ADDENDUM NO.: 6

DATE OF ADDENDUM: September 12, 2016

**Replacement of the Tile Roof on Galley Building  
Cheshire Correctional Institution  
900 Highland Avenue  
Cheshire, CT  
BI – JA – 471**

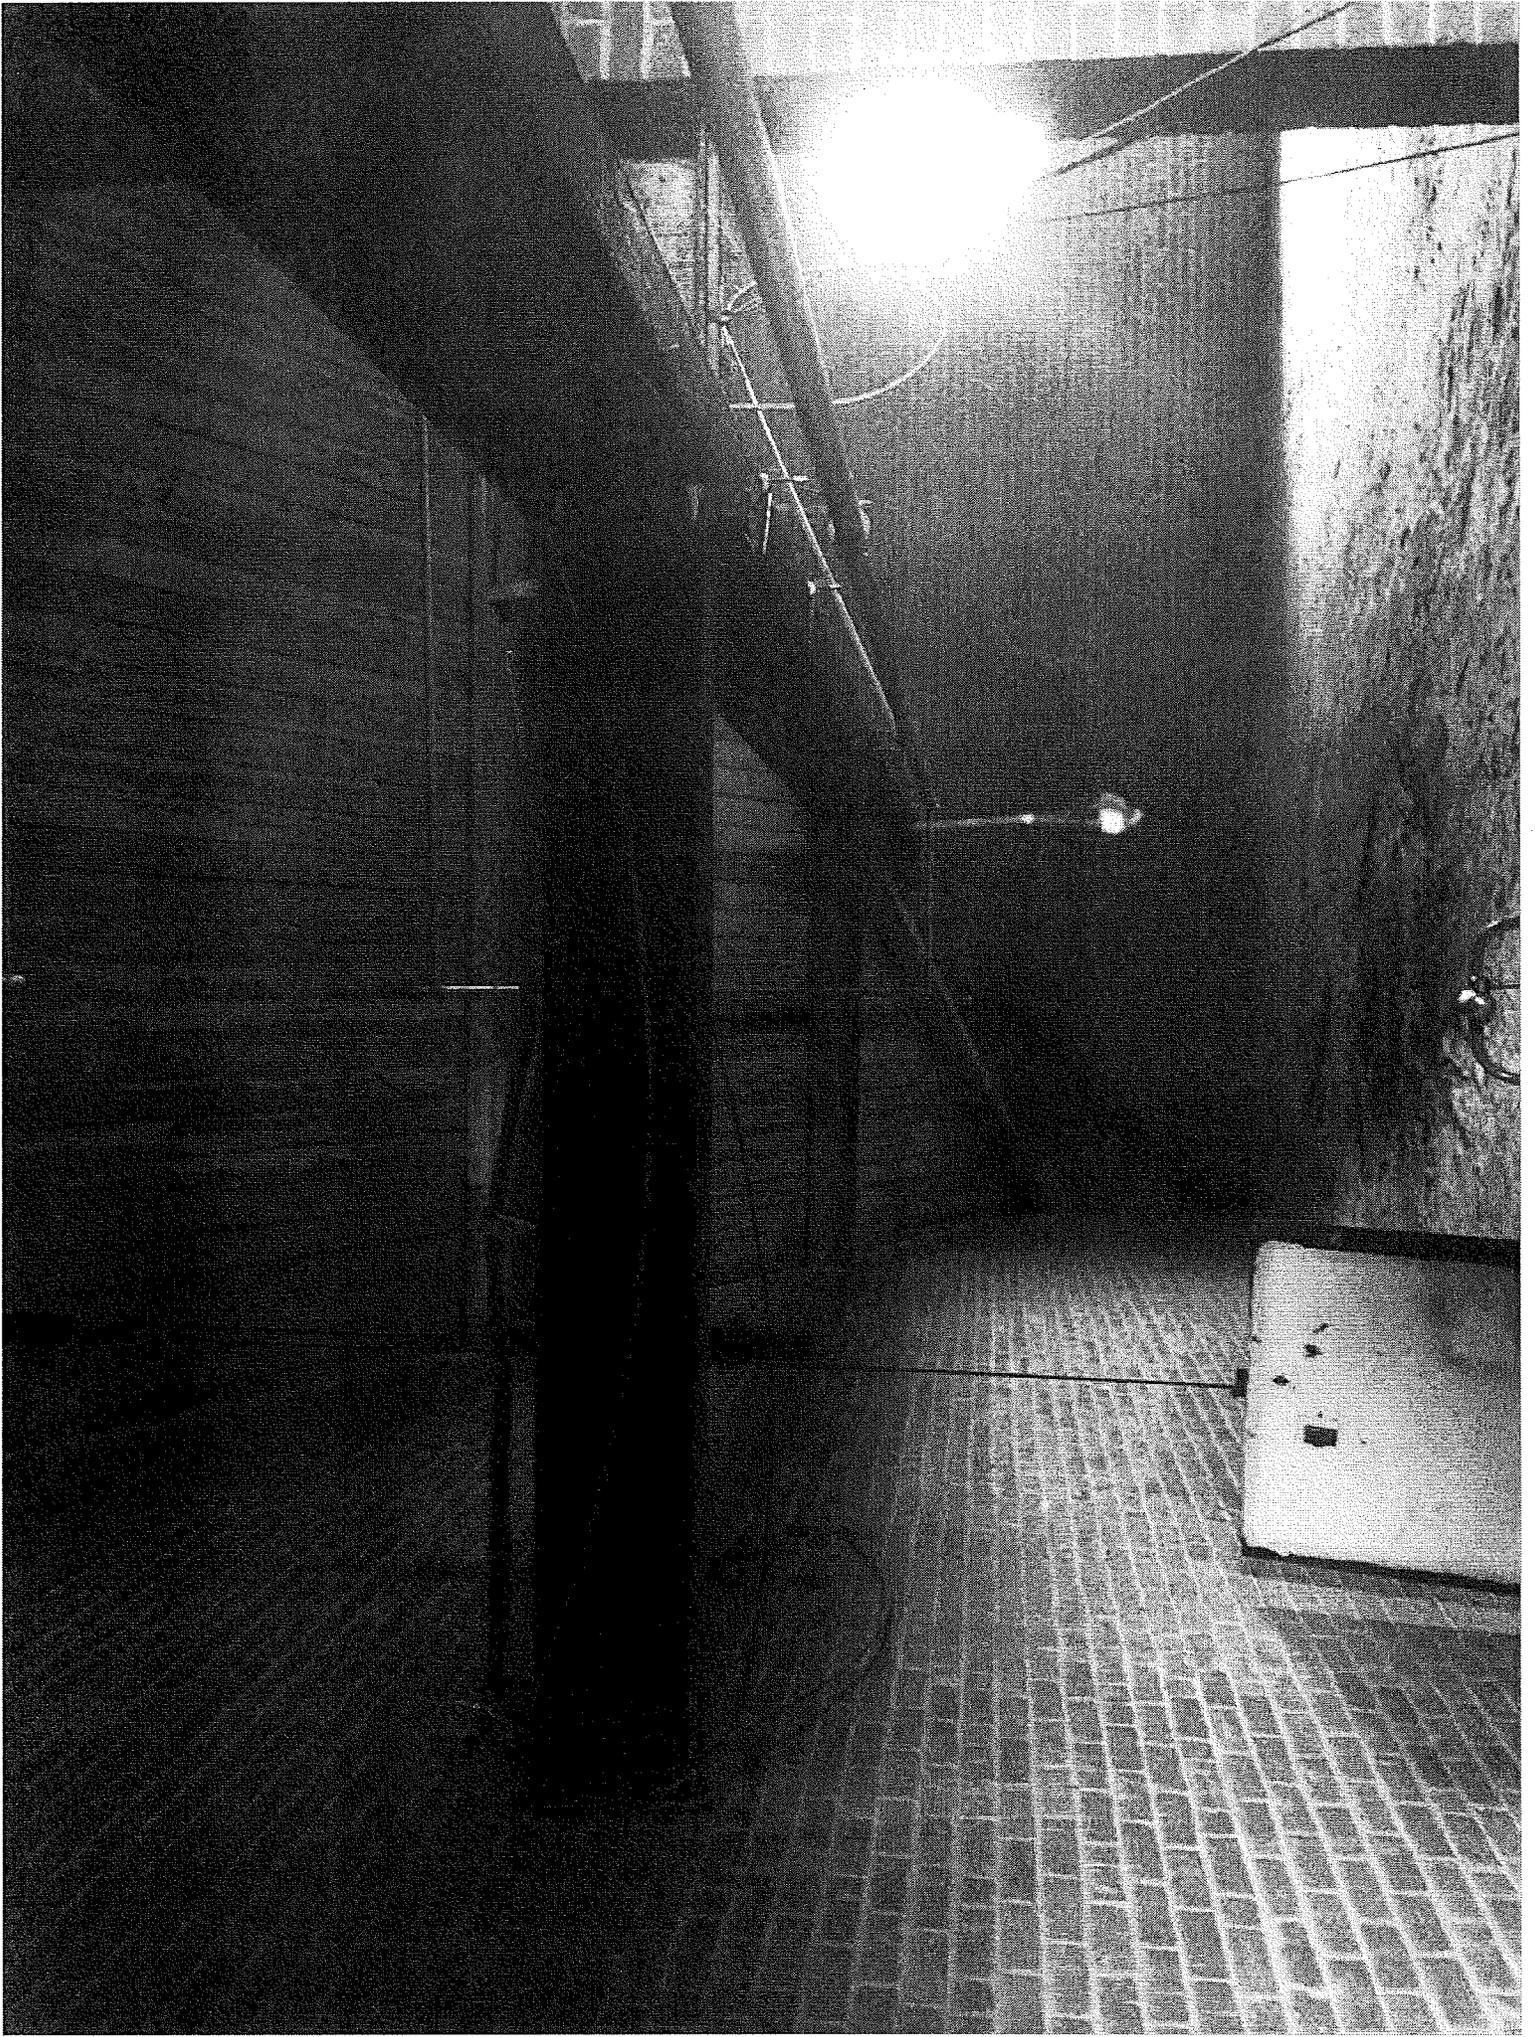
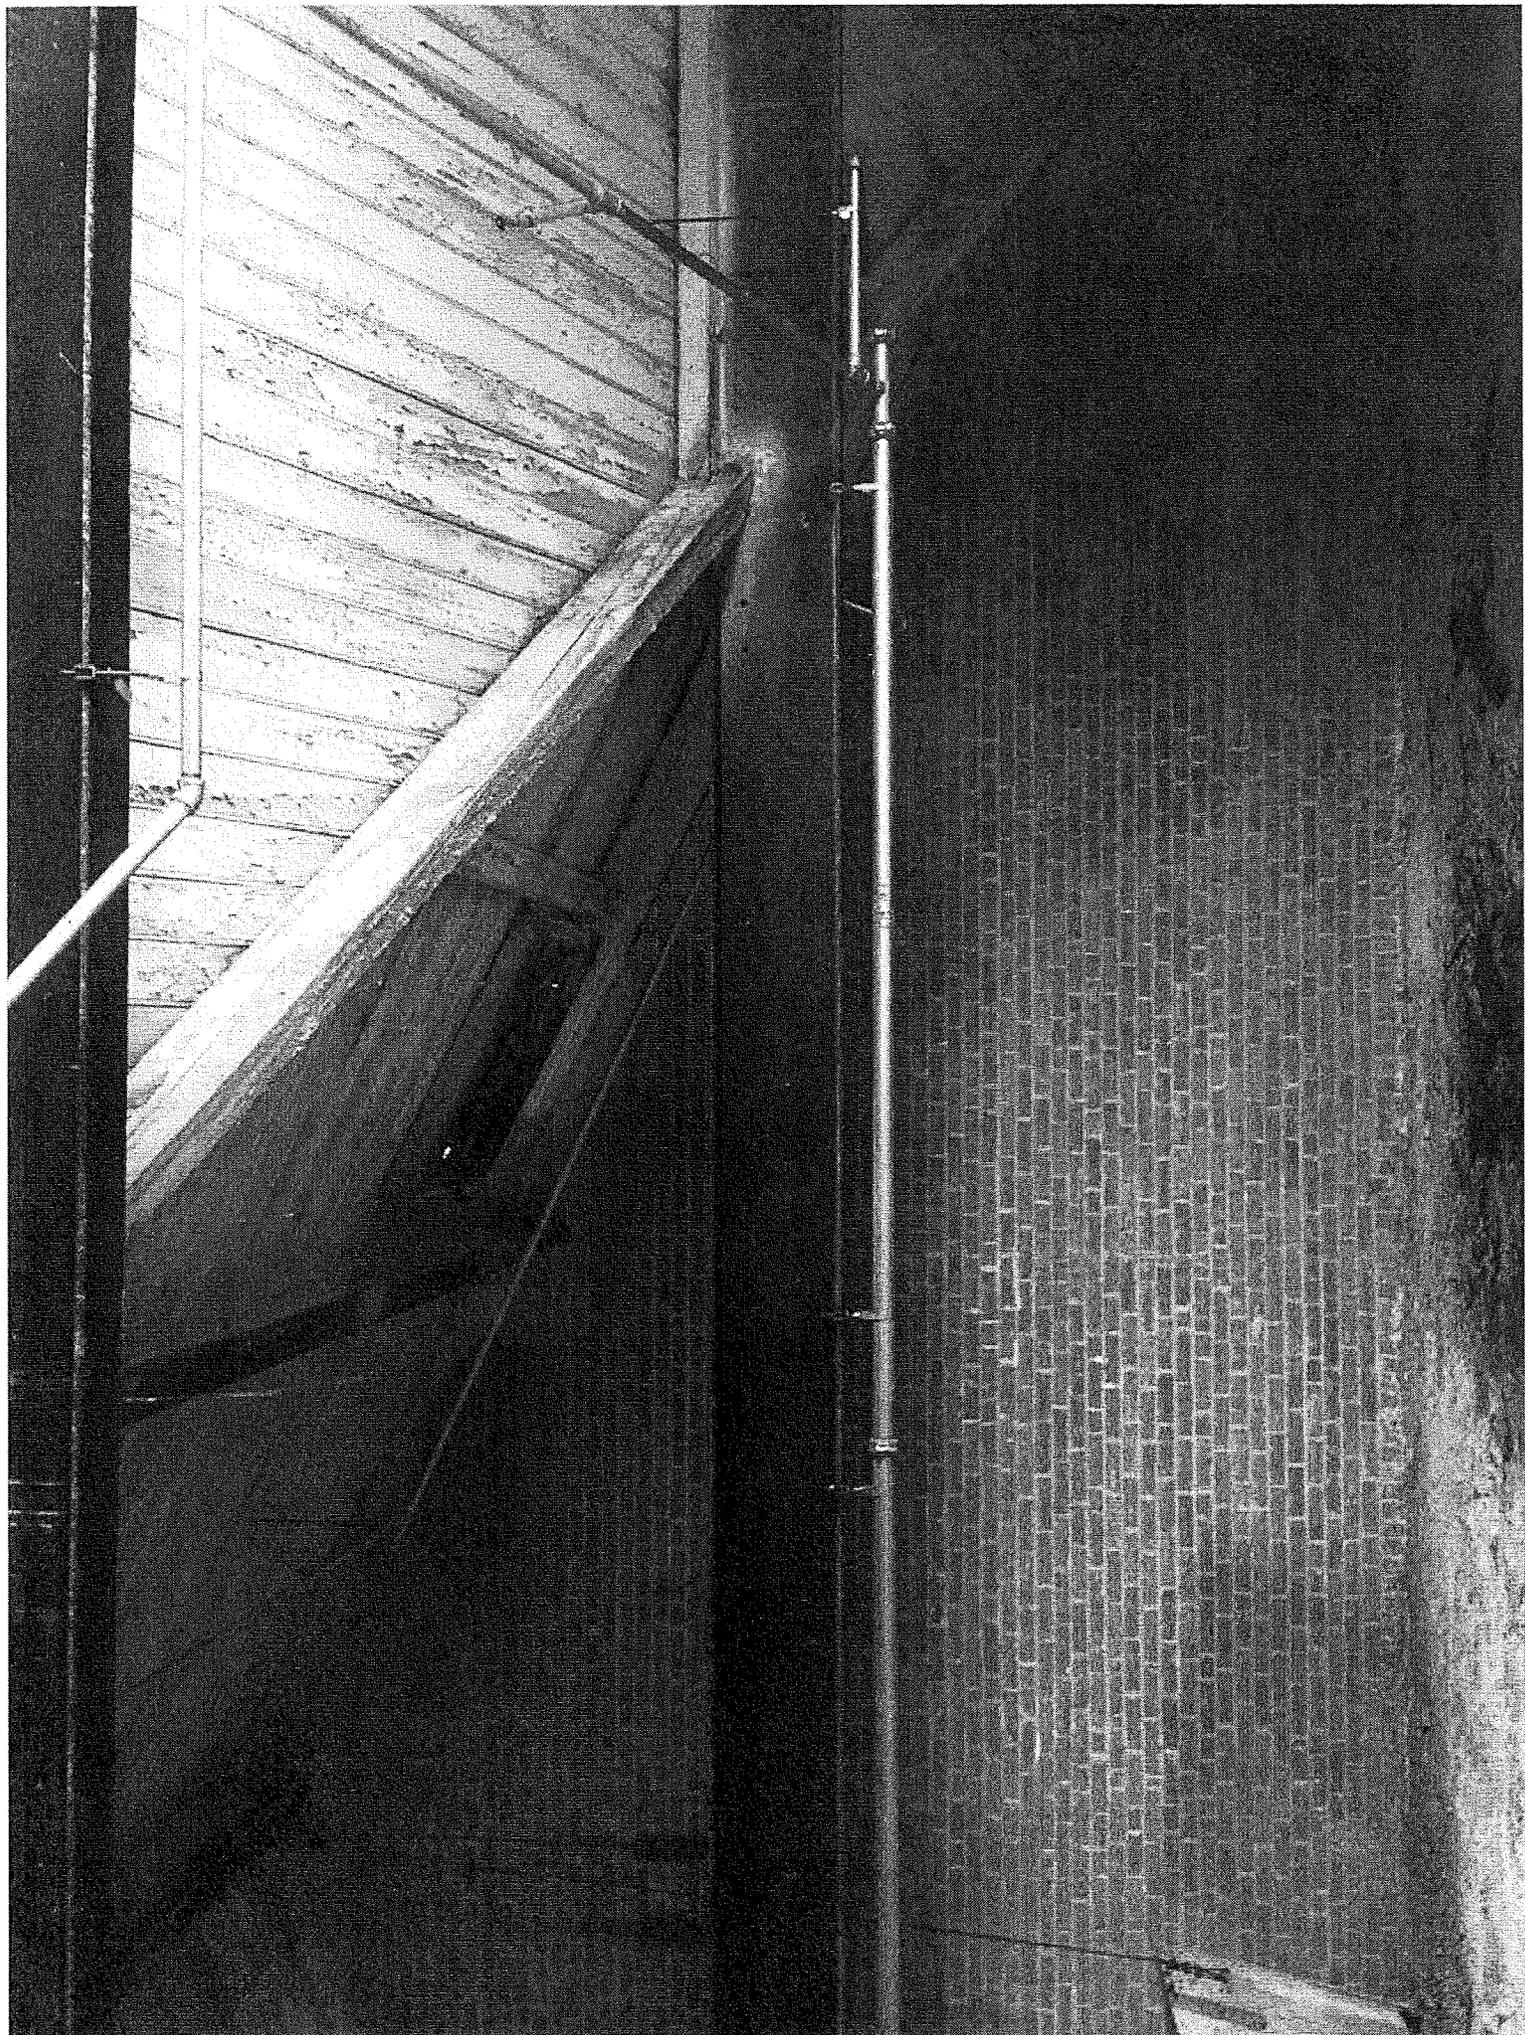
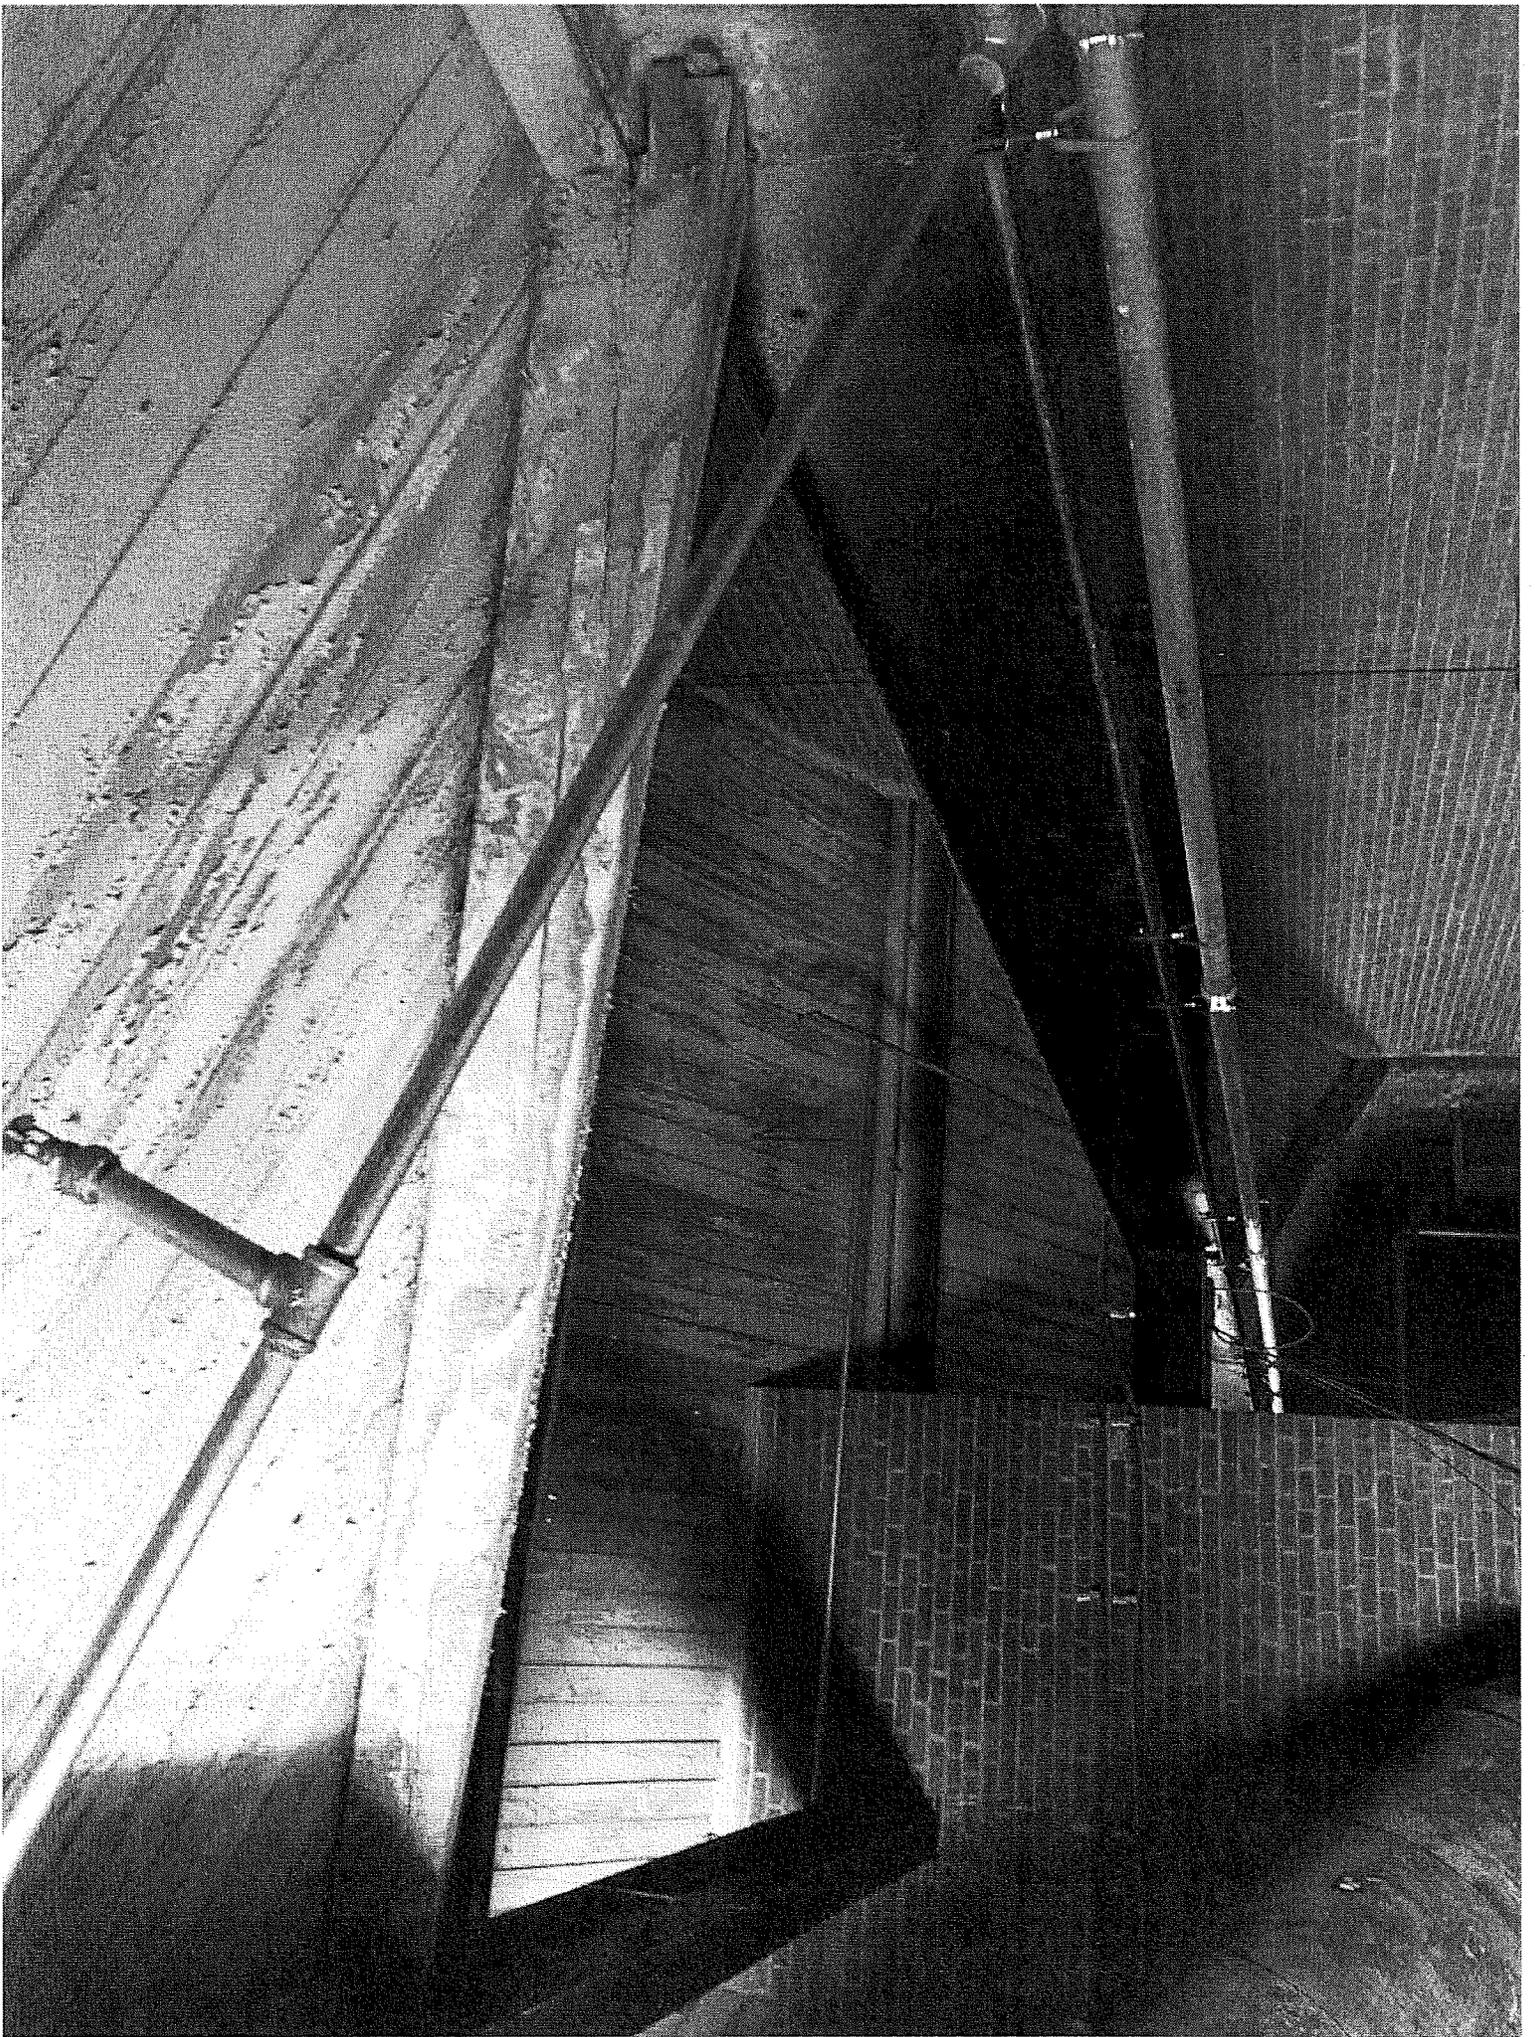
**A: 21 12 13, 1.03A requires, "The scope for Wet Pipe Sprinkler Systems is limited to the work required to remove components where supporting parts of the building are being removed, and reinstalling components after the removed building items have been replaced." This includes the sprinkler piping supported by Beams #1 & #2 to be installed the full width of the building underneath existing beams. Contractor shall include this work in the base bid. The three photos on S001 are included as part of this addendum and they show the associated sprinkler piping.**

3. Q: Sheet S001 has 3 photos of the attic spaces that are not clearly depicted black and white. Can these be sent out to bidders as separate color photographs?

- A: The three photographs are included as part of this addendum.**
4. Q: Note 2 on S502 requires us to remove and reinstall all MEP/FP supported by existing framing. Please clarify this scope of work or establish an allowance.
